ITEM FOR ENVIRONMENTAL COMMISSION AGENDA

NAME & NUMBER OF PROJECT: SP-2019-0108D Thaxton Road Tract Offsite Wastewater Improvements

REQUEST: Variance request is as follows:
Request to vary from LDC 25-8-261 to allow development within a Critical Water Quality Zone

STAFF RECOMMENDATION: Staff does not recommend this variance, having determined that the findings of fact have not been met.

WASTEWATER LINE 'A' (10+00 - 19+00)

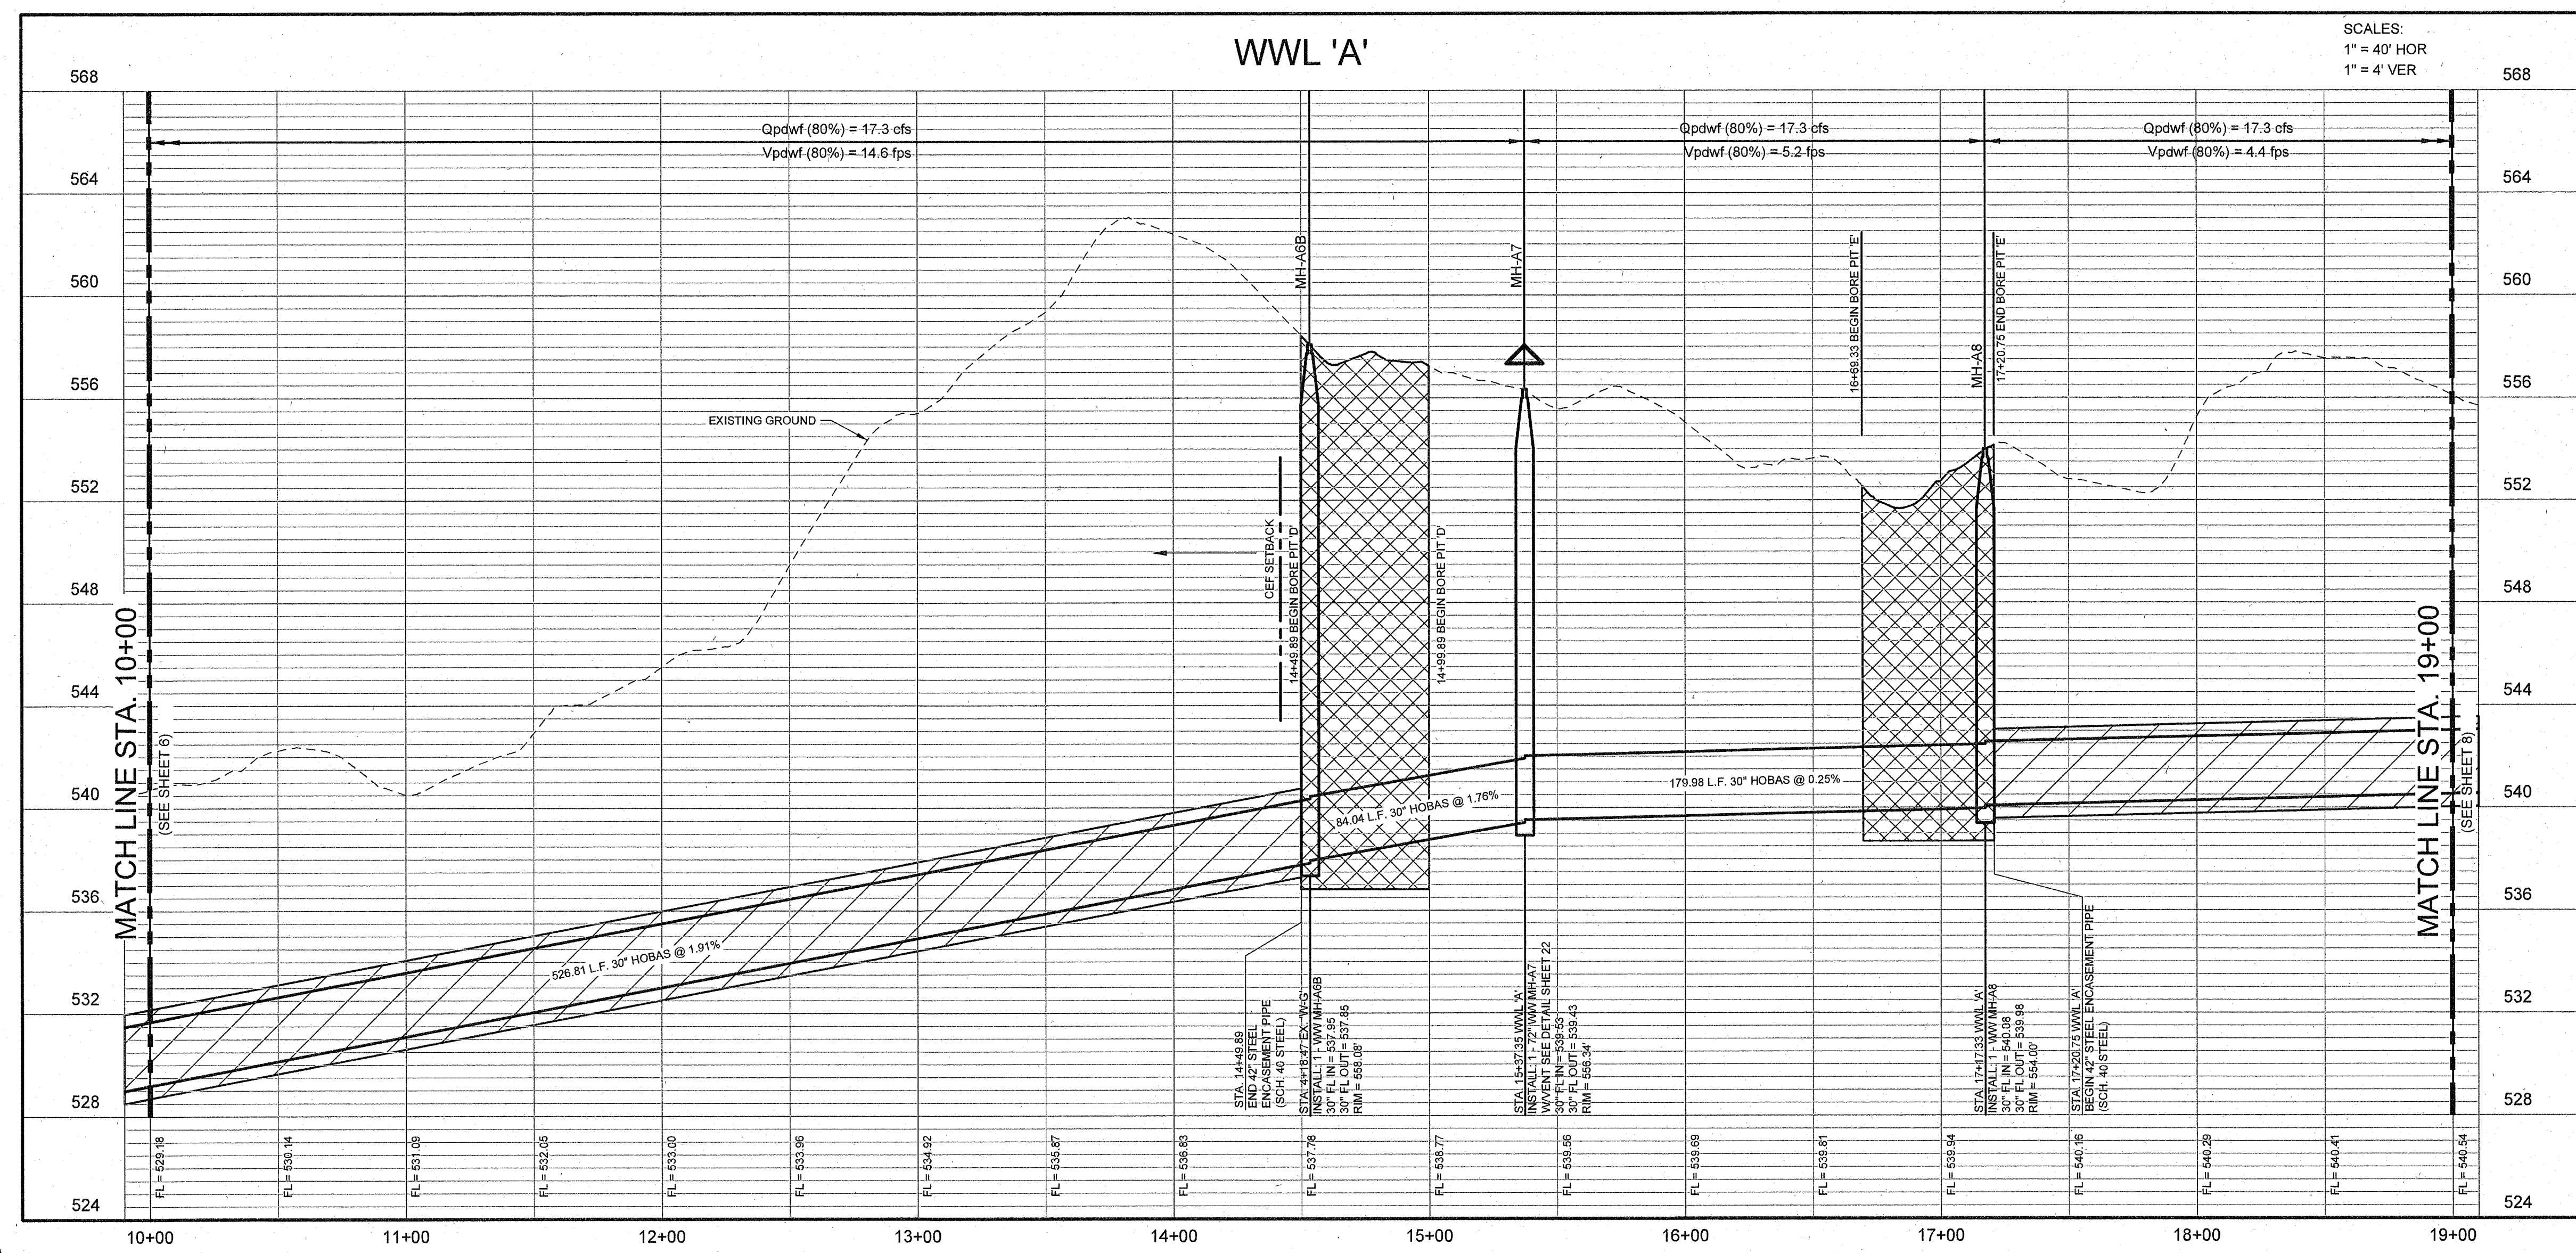
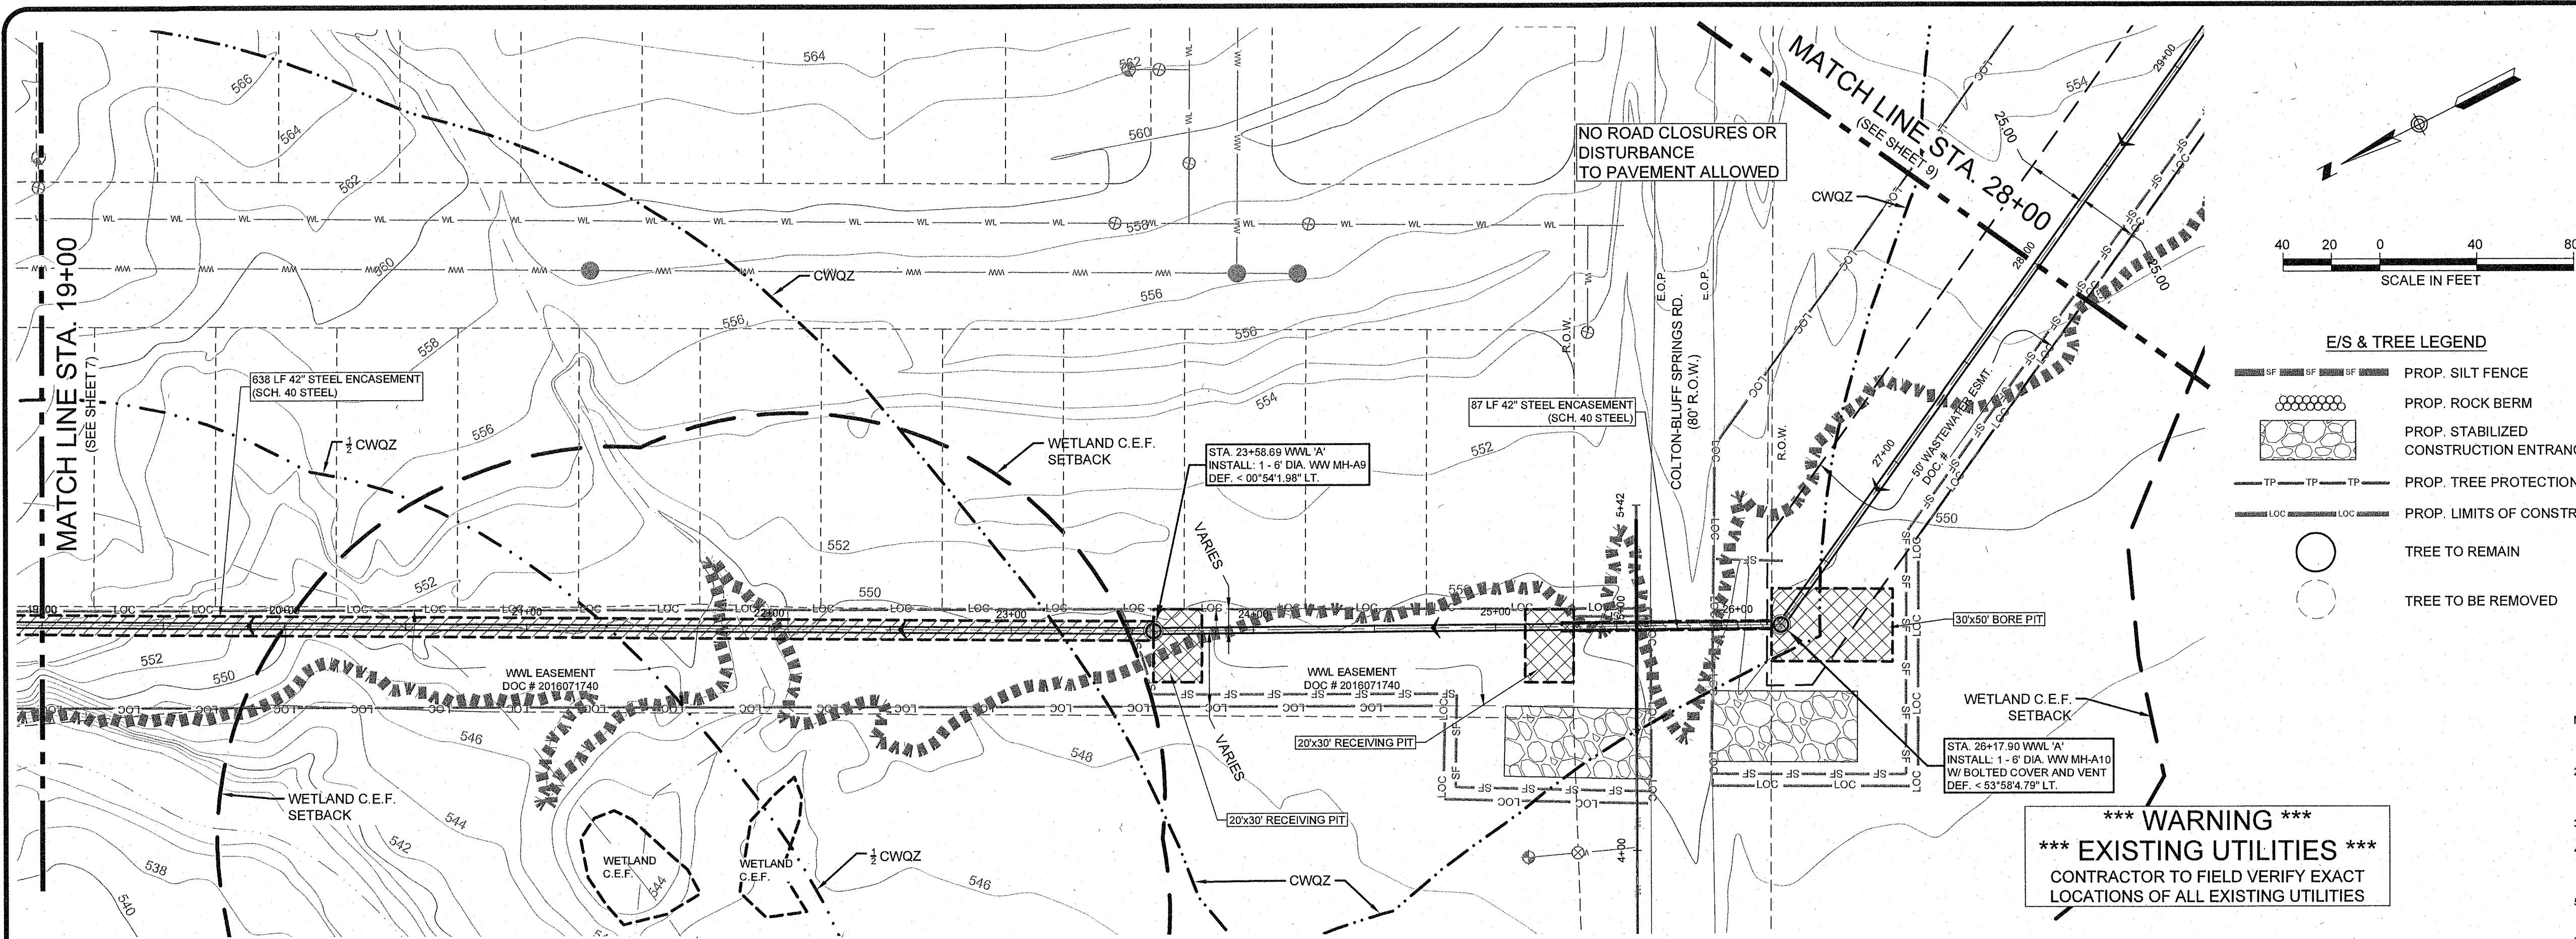
No. Alternative alignments that would not encroach into the minimum setback of the critical water quality zone exist. However, the applicant intends to take advantage of an already dedicated easement and provide a gravity-fed wastewater line, rather than dedicate a new easement within the right-of-way and provide a force main line with lift stations, as needed. As proposed, the wastewater line will result in permanent alteration of the critical water

quality zone and does not provide greater overall environmental protection because of the potential for leaks and breaks in the line resulting in sewage overflows into clean-flowing creeks.

No. As currently designed, the proposed wastewater line construction intends to bore under the critical water quality zone and the erosion hazard zone, with an overall approximate average depth of 8-12 feet, resulting in disturbance to subsurface hydrology and removal of native soils. The proposed wastewater line will require future repairs from eventual breaks and sewage overflows, which will require trenching to repair the line that equates to removal of riparian vegetation and disturbance to hydrologic functions.
